Inspection Report for B-40-280

W GRANTOSA DR WB over STH 145-W FOND DU LAC AV
Jul 21,2018

Bridge Asbestos Inspection Report

GRAEF has submitted the attached Bridge Alternative Life Cycle Cost Analysis for the Grantosa Drive bridges of STH 145, Bridges B-40-280 and B-40-281. Their conclusion is that Alternative 1 – Redeck and conversion to a semi-expansion abutment has the lowest first cost and lowest life cycle cost. Please review the analysis and comment on their recommendation of Alternative 1 as the preferred option.

Figure 1: Conversion to Semi-expansion Abutment

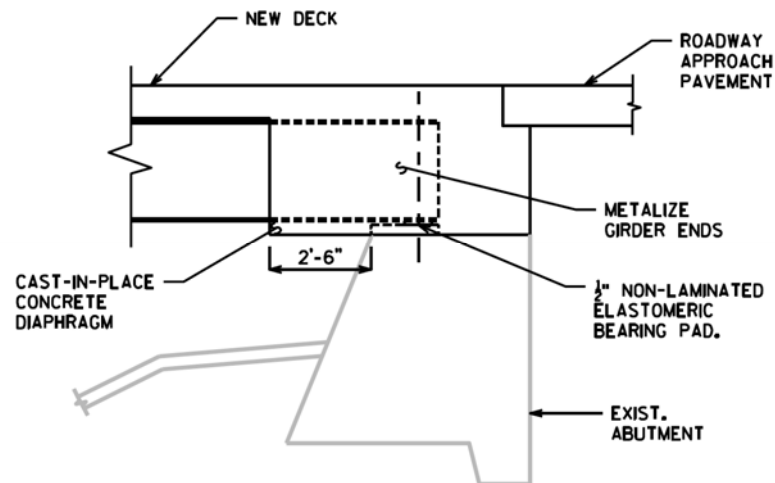
Kevin and Mary Beth – Please respond to Tony’s comment regarding the LCC analysis for Alternatives 3 & 4 and resubmit is necessary. Thanks.

The memorandum has been revised as per discussions with Consultant.
